**PLANNED UNIT DEVELOPMENT  
& SUBDIVISION STAFF REPORT****Date: May 20, 2010****DEVELOPMENT NAME**

Checkers St. Stephens Road Subdivision

**CONTEMPLATED USE**Planned Unit Development Approval to allow two  
buildings on a single building site, and Subdivision approval to create 1 lot.**TIME SCHEDULE****FOR DEVELOPMENT**

# SITE PLAN

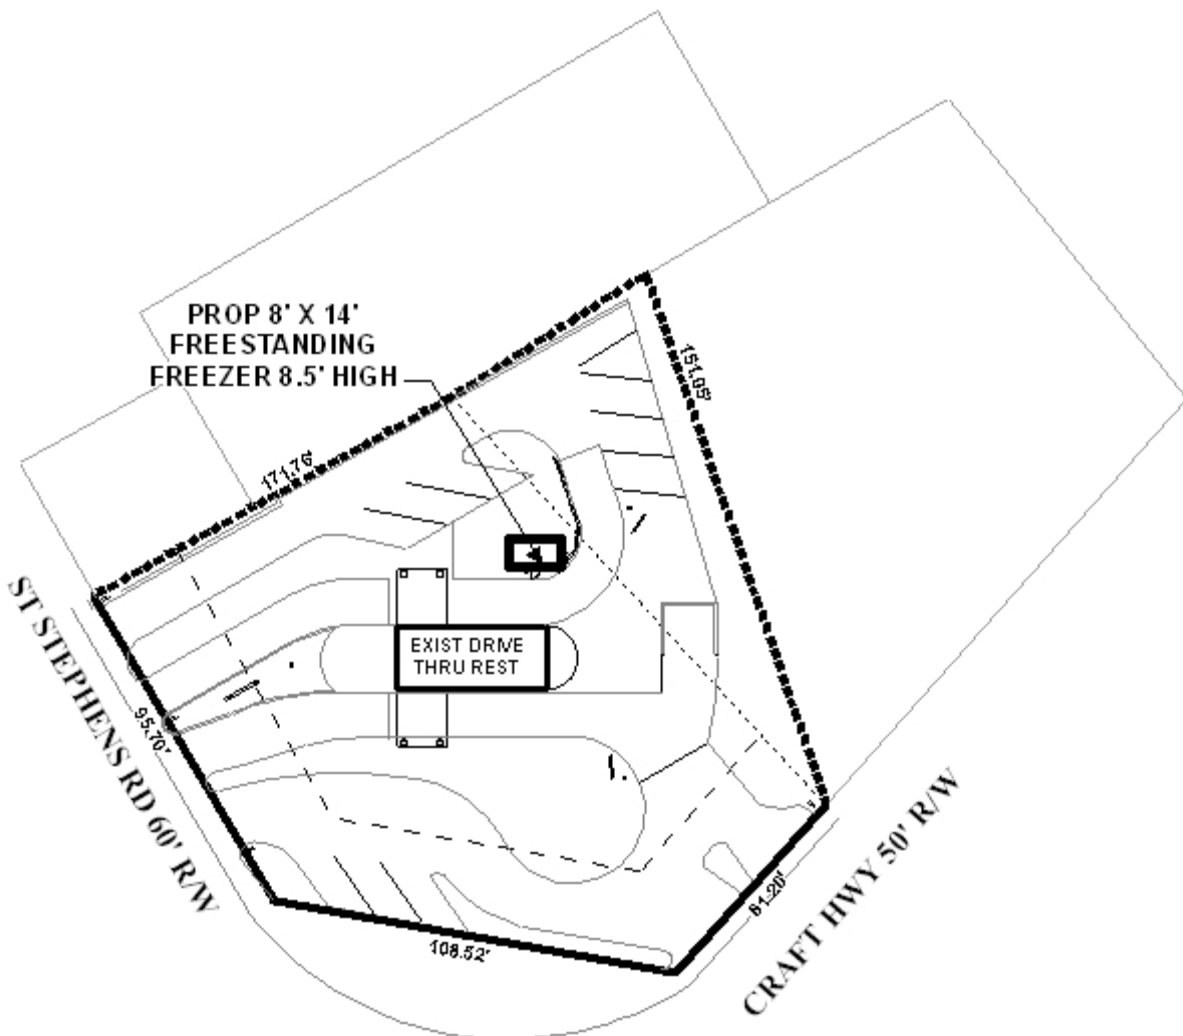
The site is currently developed with an 800 square foot Checkers drive-through restaurant, with one walk-up window and outside seating (5 tables). A 112 square foot freestanding freezer, the reason for the application, is located in a paved area. The site plan indicates that the site has 10 parking spaces, as do the 2006 aerial photographs: four of the parking spaces on the East side appear to be substandard in terms of length.

It should be noted that circulation on the site is extremely constrained, thus deliveries by trucks would likely block a portion of the site's circulation.

The site is zoned B-3, Community Business District, thus the current use is allowed by right. Parking for the use is calculated as one parking space for each outside table, and one space per employee. As previously mentioned, there are 10 parking spaces on the site for 5 tables and an unspecified number of employees. As the Checkers main building is 800 square feet, the Chief Building Code Official states that the maximum occupancy of the structure would be 8 employees, thus the site lacks adequate parking – 13 parking spaces are required. Also, as previously mentioned, it appears that four of the parking spaces do not appear to meet minimum dimension requirements. An application to the Board of Adjustment should be required to address the parking ratio deficit, or removal of outdoor seating to bring the site into compliance.

The preliminary plat and the PUD site plan reflect the 25-foot setbacks from street frontages required by the Subdivision Regulations, and the Zoning Ordinance for B-3 districts.

Finally, no information has been provided regarding tree and landscape compliance for the site. It appears that the site was developed after the tree and landscape requirements were fully in effect, however, there are no frontage trees on the site, and an inadequate amount of perimeter trees. An application for land disturbance will be required as part of the tree and landscape compliance process.

- 5) Application for a land disturbance permit for the frontage and parking tree compliance requirements prior to the signing of the final plat;
- 6) Successful application to the Board of Adjustment for a parking ratio variance (and other variances as needed), or removal of a sufficient quantity of outdoor seating to bring the site into compliance with the minimum required parking ratio;

- 7) Provision of two (2) copies of the revised PUD site plan, if approved, prior to the signing of the final plat; and
- 8) Full compliance with all other municipal codes and ordinances.
